Committee: South Planning Applications Committee
Date: 13 December 2022
Report Title: 21/04728/FUL: Scottish Hydro Electric Transmission Plc
Land 1185M West of Knotty Wood Cottage, Farr
Report By: Area Planning Manager – South

Description: Construction of the tracks to access the Knocknagael -Tomatin 275kw Over Head Line (in retrospect)
Ward: 12 – Aird and Loch Ness
Development category: Local Development
Reason referred to Committee: More than 5 objections

**Town and Country Planning (Scotland) Acts
21/04728/FUL**

**Retrospective application for the construction of the tracks to access the
Knocknagael-Tomatin 275kw Over Head Line
Land 1185M West of Knotty Wood Cottage Farr**

Figure 1 – Site setting and expected groundwater flow direction (blue arrows). Access track in green, excavated ditch in red.

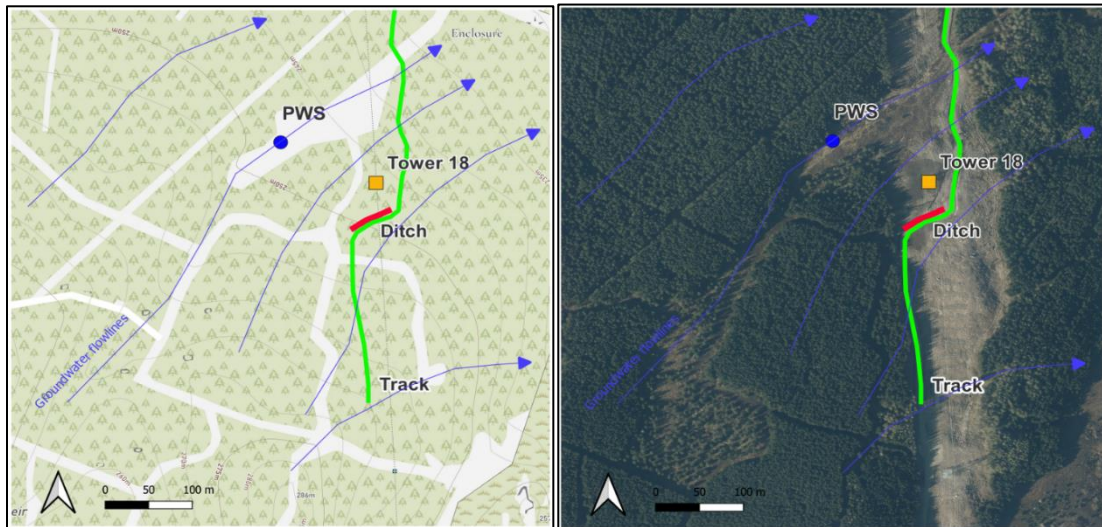
- 1.1 From the applicant's PWS reports the PWS spring serving Blar Buidhe and neighbouring properties is fed by groundwater from a shallow depth through fractures in the weathered bedrock and from surface water runoff. The groundwater flow direction is expected to mirror the surrounding landscape. As such it is expected that groundwater flows toward the PWS source in a southwest to northeast direction. SEPA is in general agreement with this assumption.
- 1.2 Where the groundwater flow direction is interpreted to mirror topography, groundwater flow lines can be mapped using the ground elevation contours. Groundwater flow can be drawn as perpendicular to the contour levels following the topographic gradient as shown in Figure 1 below.

1.3 The excavated ditch, which is the subject of this note, is located adjacent to the Track 3 section within a 250m radius from the PWS source and appears to be deeper than 1m (Figure 2). The ditch, or part of it, is located at a higher elevation than the PWS. However, groundwater flow is highly unlikely to be directed from the ditch area to the PWS source as this would infer a direction from southeast to northwest almost parallel to the elevation contours and perpendicular to the expected groundwater flow direction in this area – i.e., the ditch and the PWS are located side gradient to each other. In these settings, a potential diversion of groundwater caused by the ditch excavation would have no effect on the groundwater quantity available to the PWS.
